**Re: Initial Submission Review Comment Responses – The Overlook at Kings Point South – Zoning Map
Amendment and Master Plan**

Application Number: DA-1628-08

Case Numbers: 2023-2004-00, 2023-2003-00

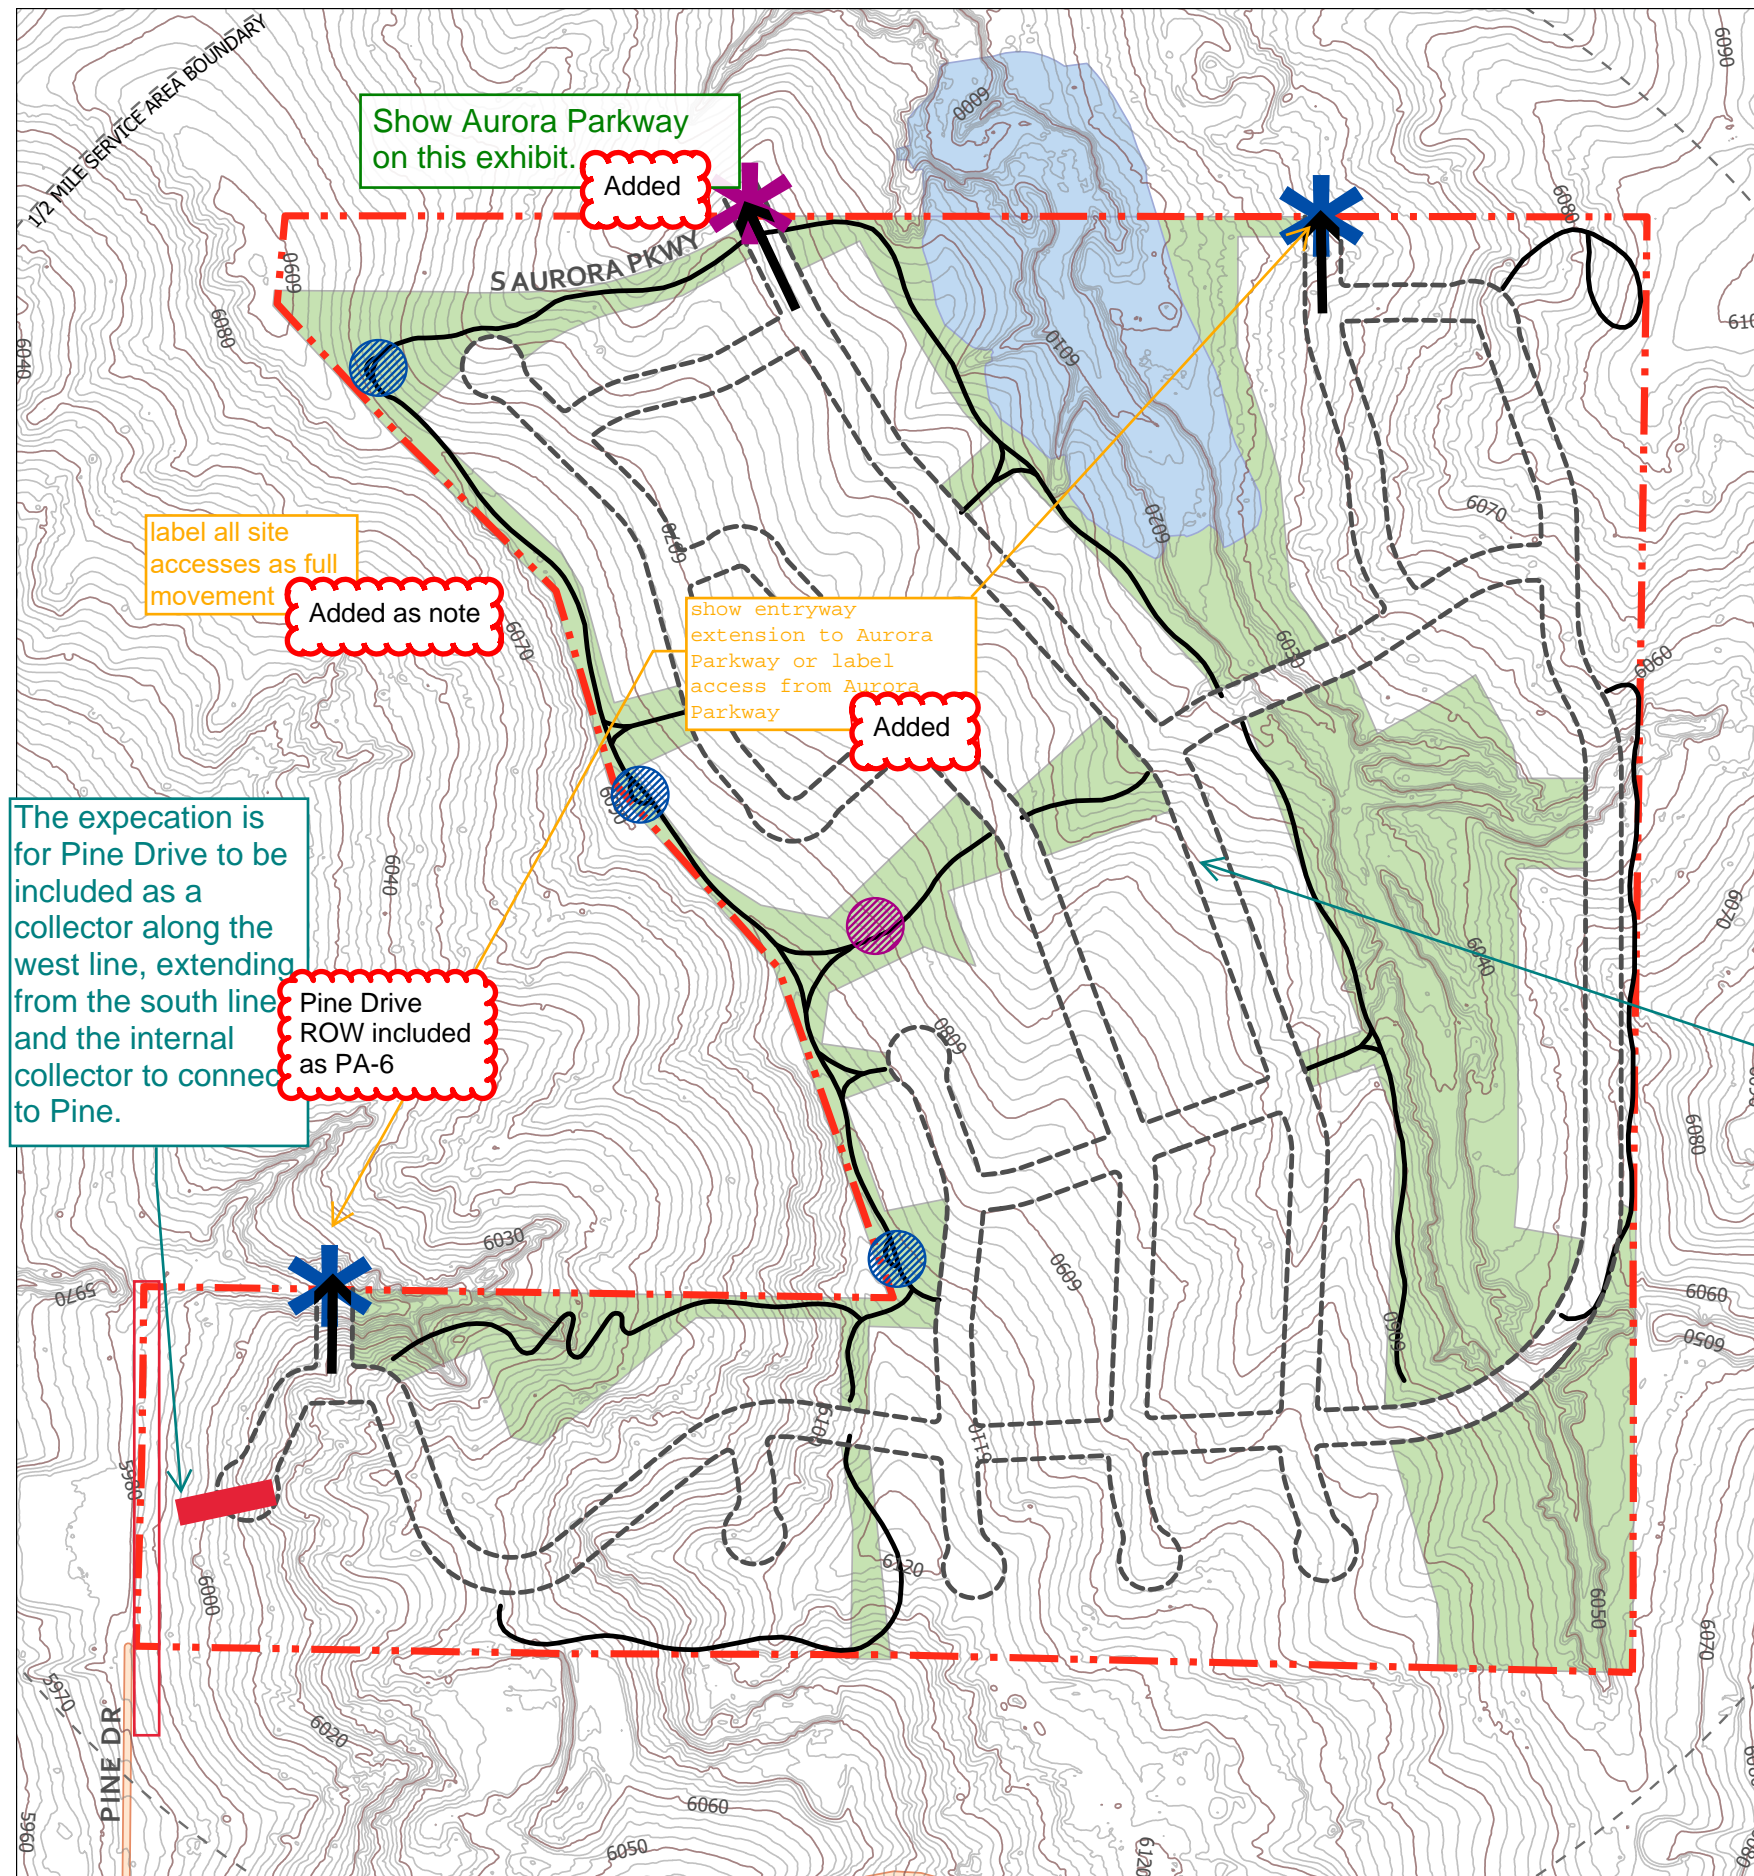
Add "conflict"

Add "the"

Added

PUBLIC IMPROVEMENT PLAN EXHIBIT
OVERLOOK AT KINGS POINT SOUTH
REGIONAL OFFSITE IMPROVEMENT & OVERALL PLAN

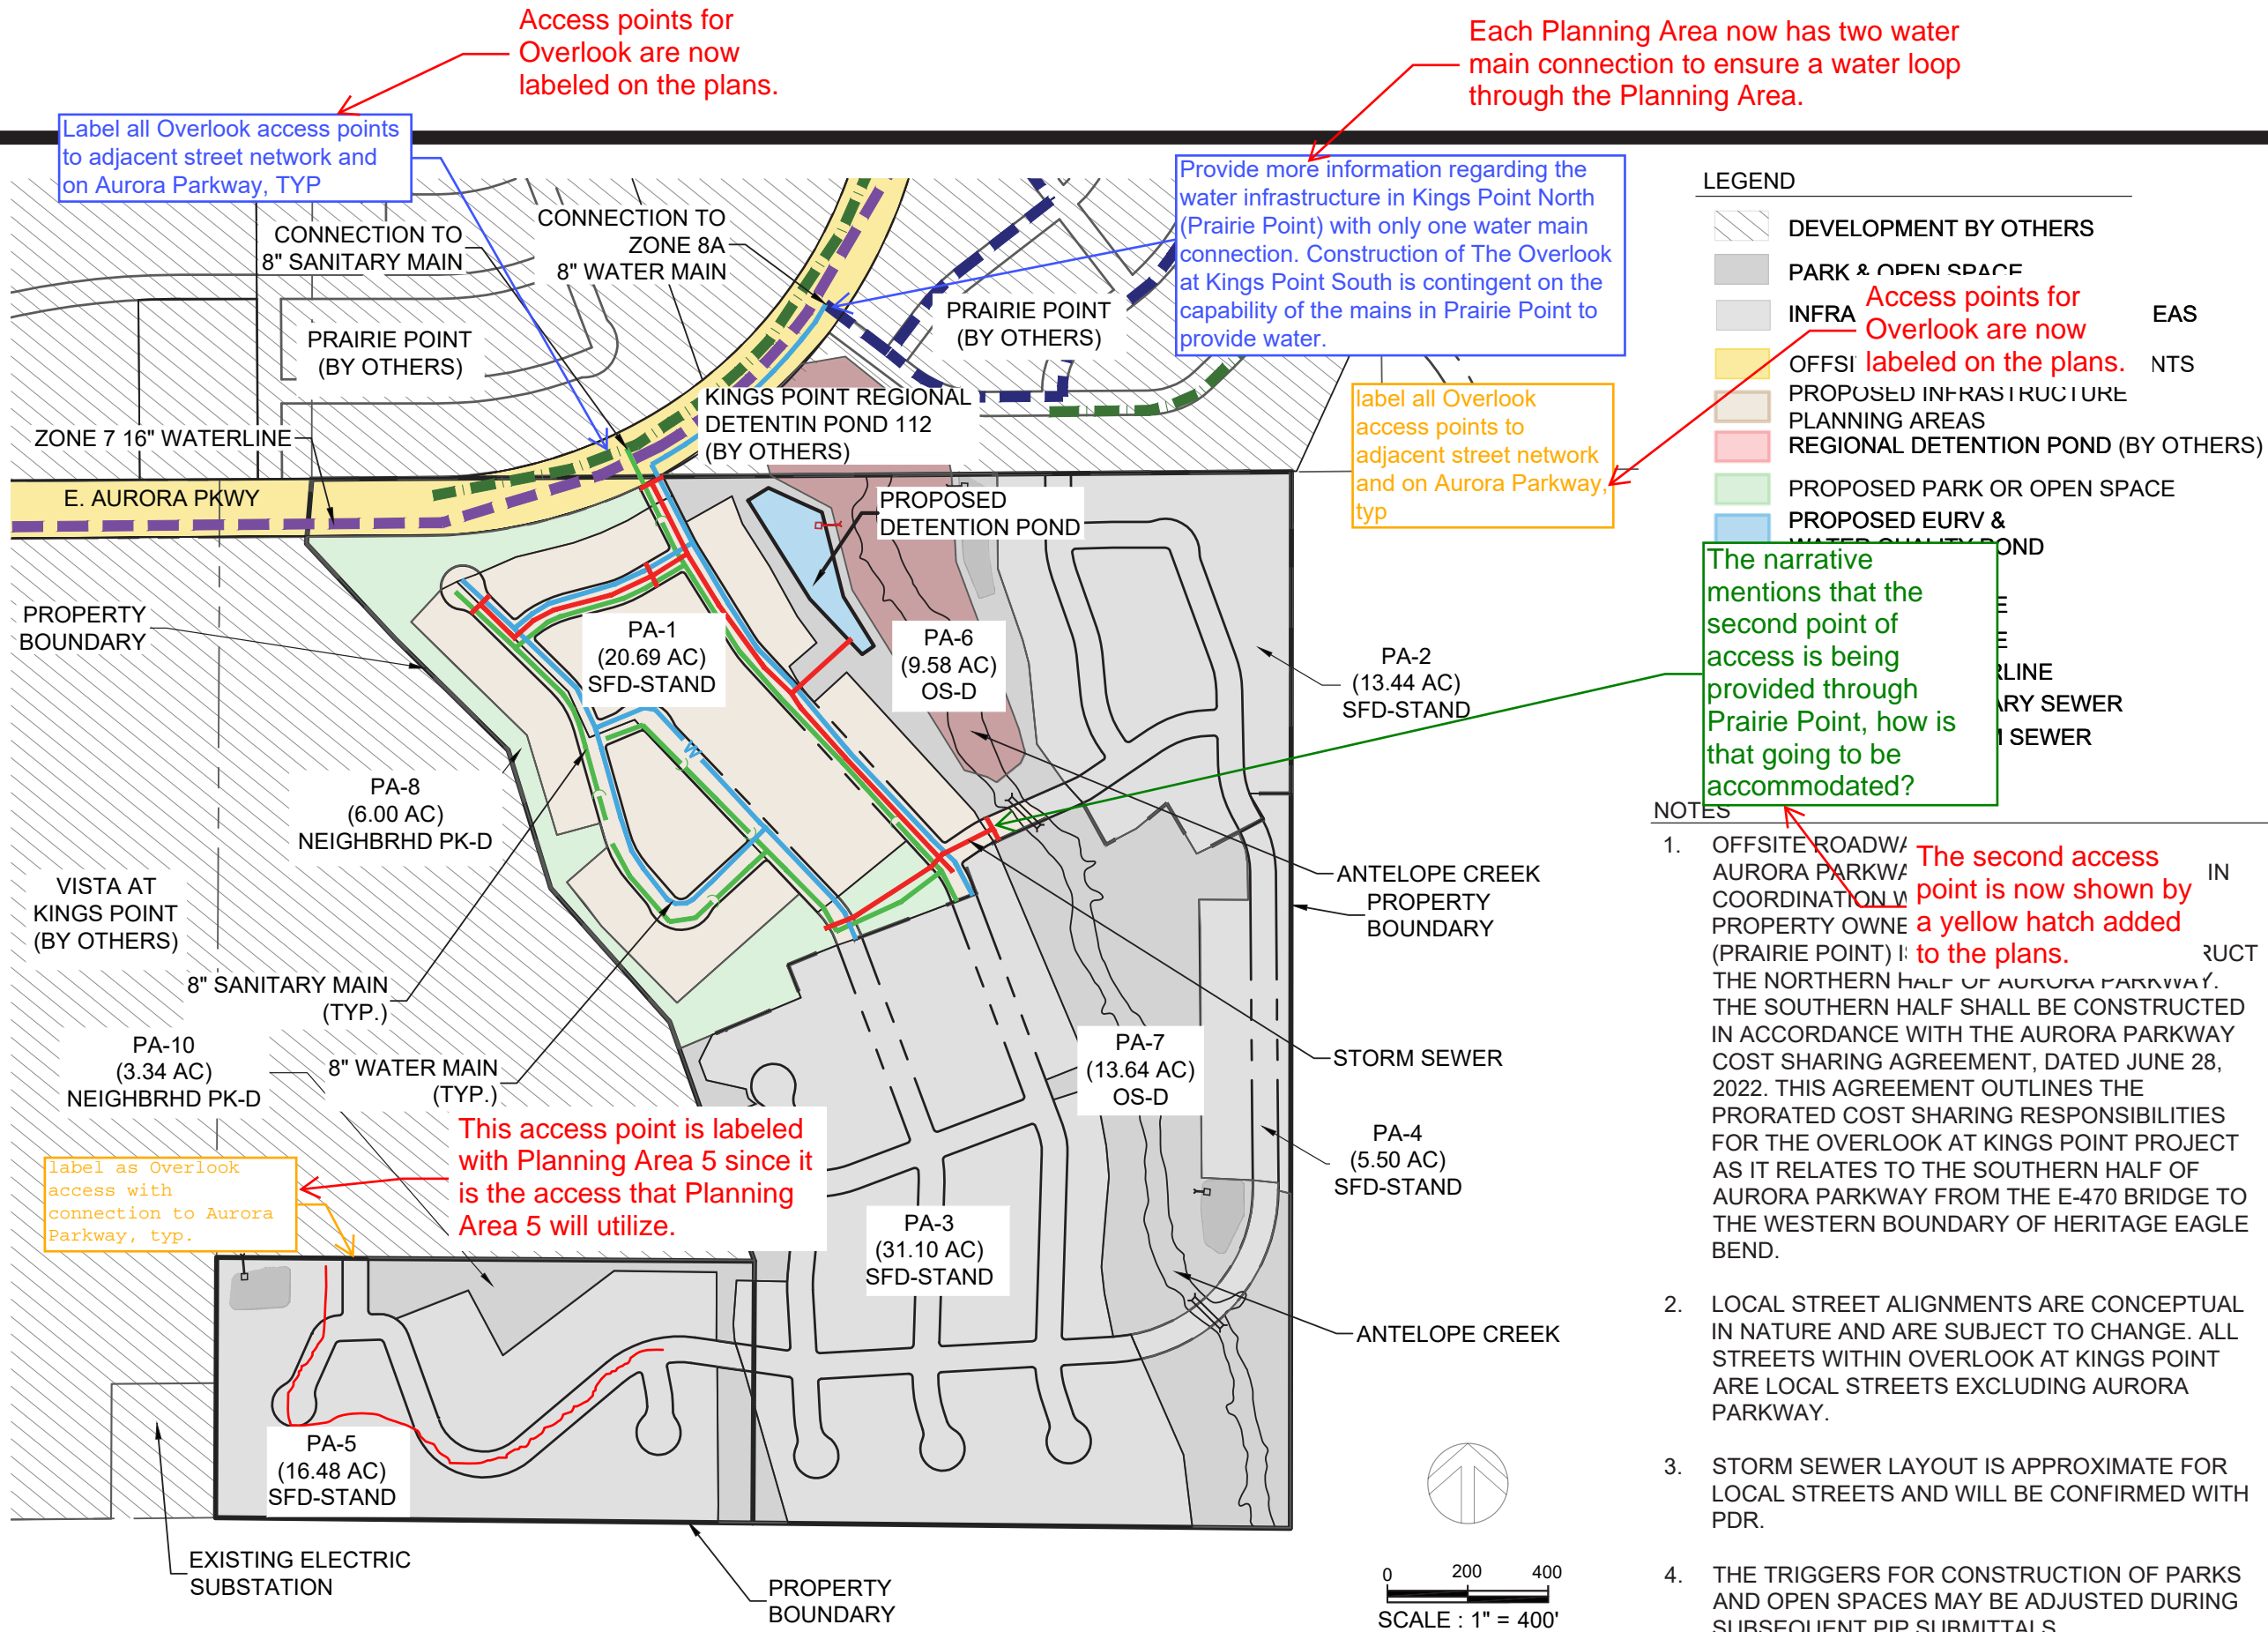
Overall Requirements: two points of paved emergency access, looped water supply and all off-site roadways necessary to provide the two distinct points of access to the overall site.

Offsite street improvements required in order to provide a second point of access shall be completed prior to the issuance of certification of occupancies for any planning areas.

PUBLIC IMPROVEMENT PLAN EXHIBIT
OVERLOOK AT KINGS POINT SOUTH
PLANNING AREAS 3 & 9

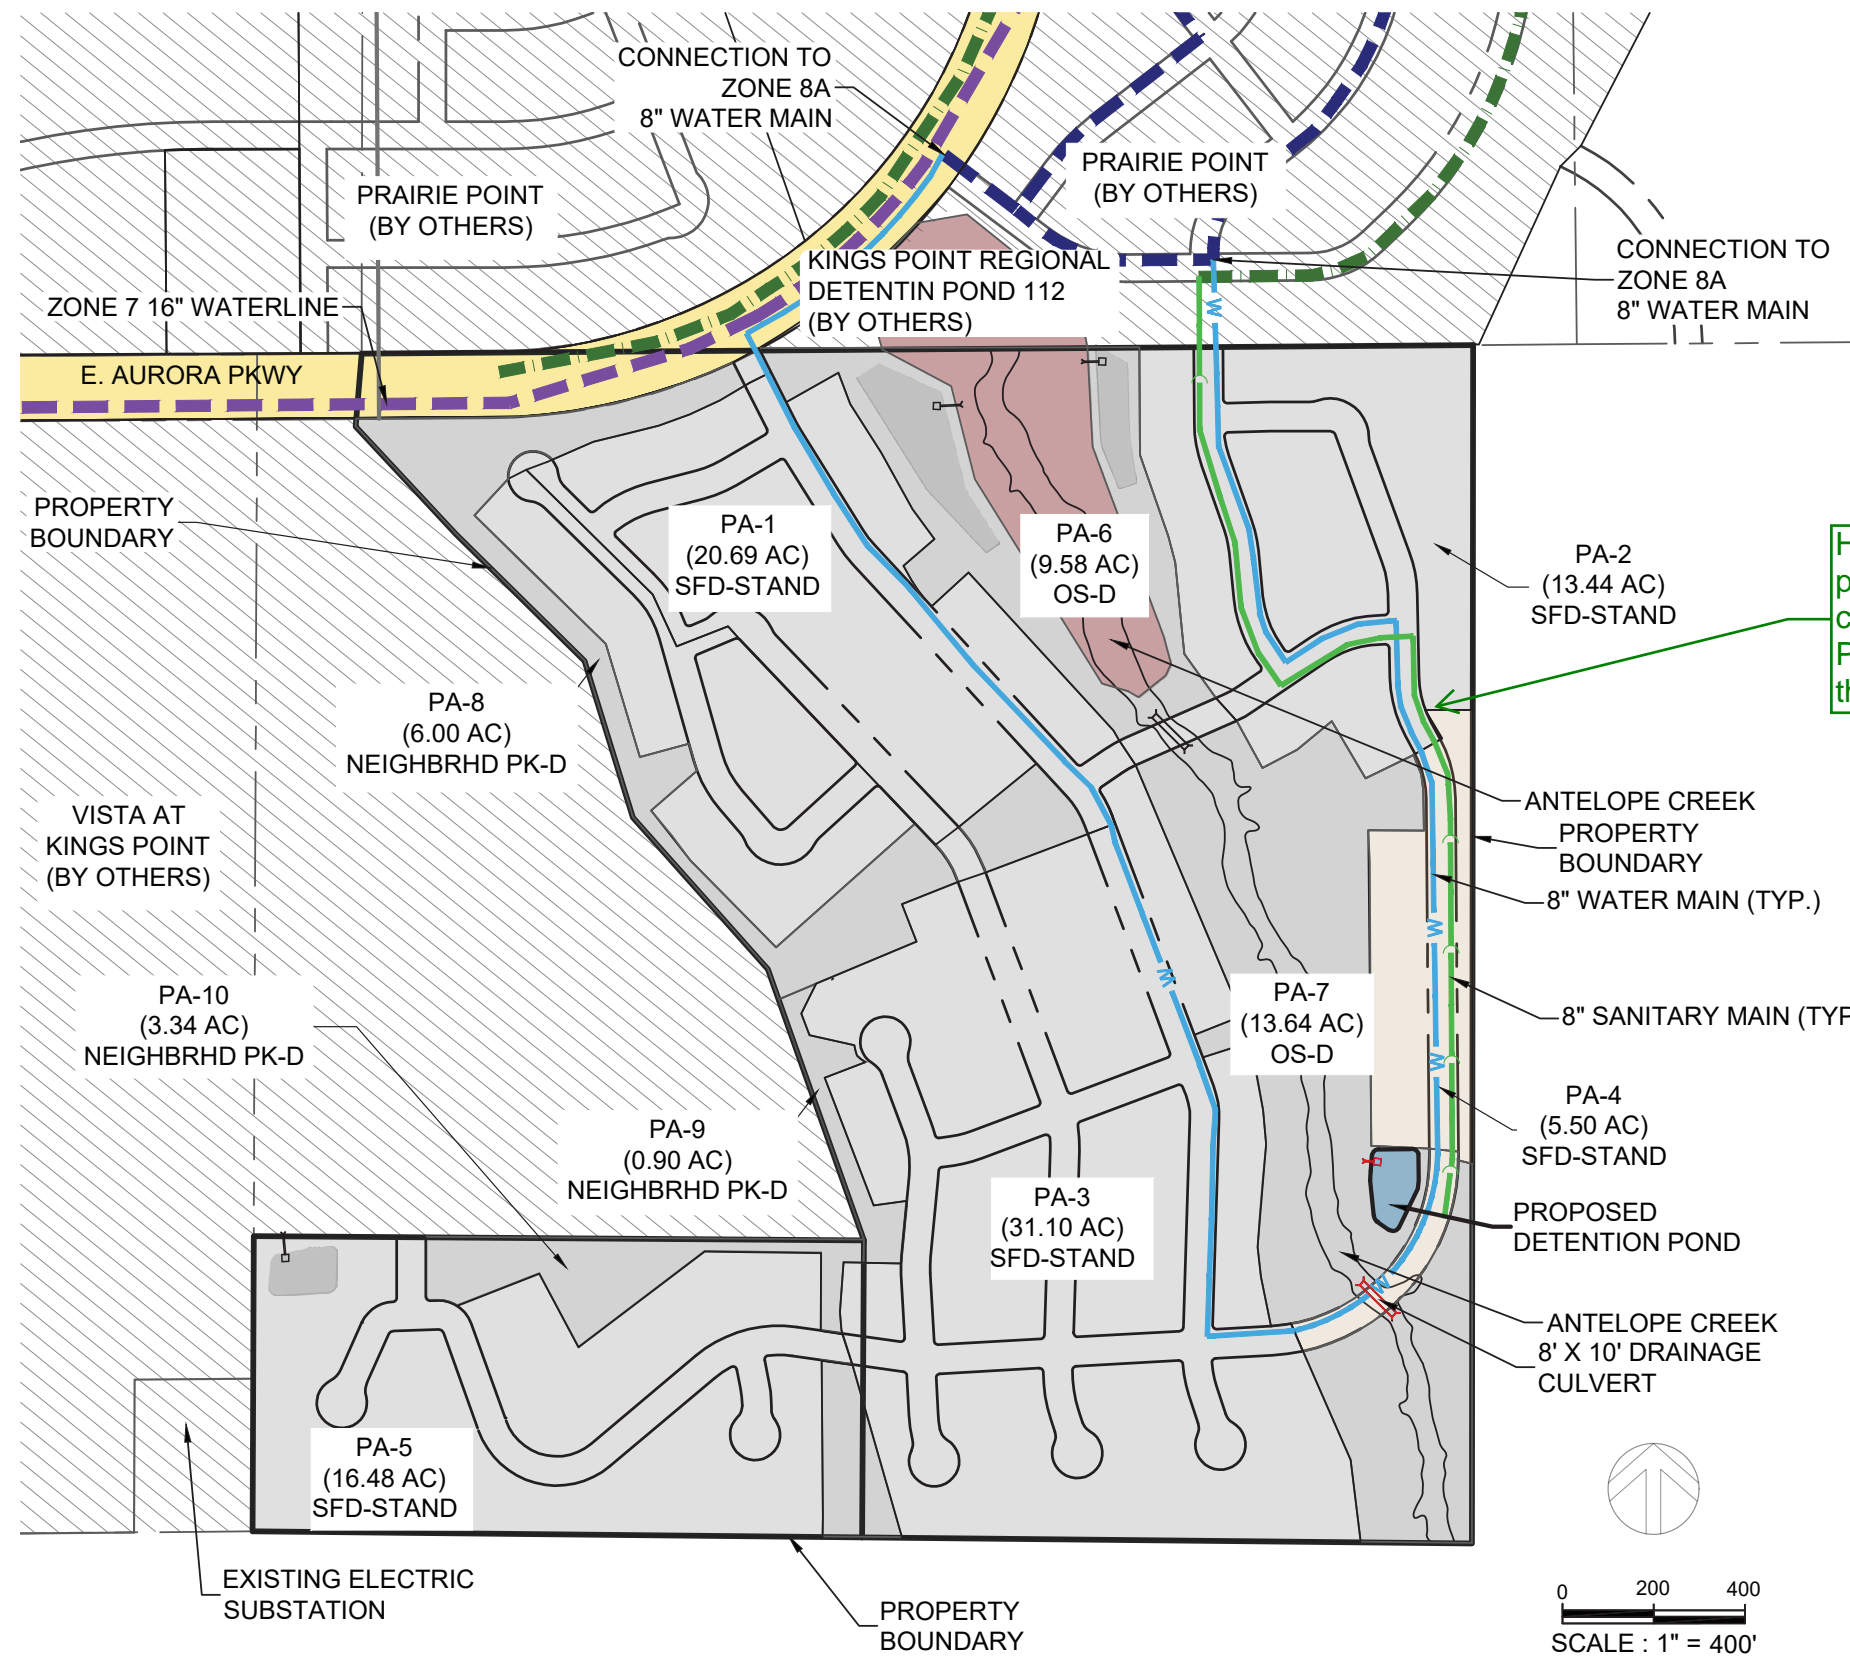
The plans now show how water will loop through the Planning Areas and not dead end.
